APPLICATION NO.	FILING DATE	FIRST NAMED INVENTOR	ATTORNEY DOCKET NO.	CONFIRMATION NO.
10/625,643	07/24/2003	Shinichiro Fujita	116668	9724

Office Action Summary	Application No. 10/625,643	Applicant(s) FUJITA ET AL.	
	Examiner Matthew Bradley	Art Unit 2187

DETAILED ACTION

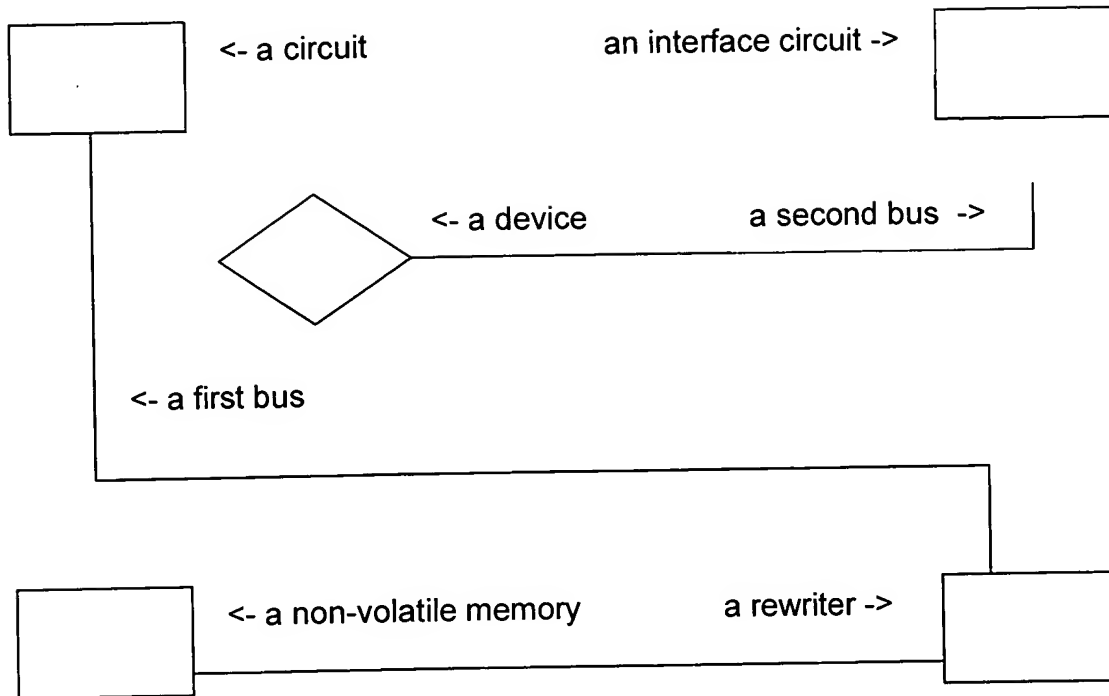
The Examiner notes that as amended, claim 1 recites, '...an interface circuit which performs interface processing with a device connected to a second bus ... a rewriter activation section which causes the rewriter to start processing when the second bus is detected to have no connection to any device.' This is indefinite. The last limitation requires the second bus to have no connection to any device, however the interface circuit performs interface processing with a device connected to a second bus. Nothing appears to be recited in the instant claim language which would allow for the disconnection of this device from the second bus to allow the rewriter to begin processing.

The Examiner would further like to illustrate, in the form of the picture shown *infra*, how the Examiner is interpreting the instant claim language in so far as it is clear:

The Examiner notes that as shown supra, the device is connected to the second bus. No other connections appear to be positively recited, although, the claim does appear to imply connections by reciting, 'data transfers through a first bus ...e.g.', clarification is respectfully requested.

Further the Examiner is also unsure how the rewriter can begin processing as no connection of the second bus to the rewriter appears to be recited; therefore how can a dis-connect occur to begin processing?
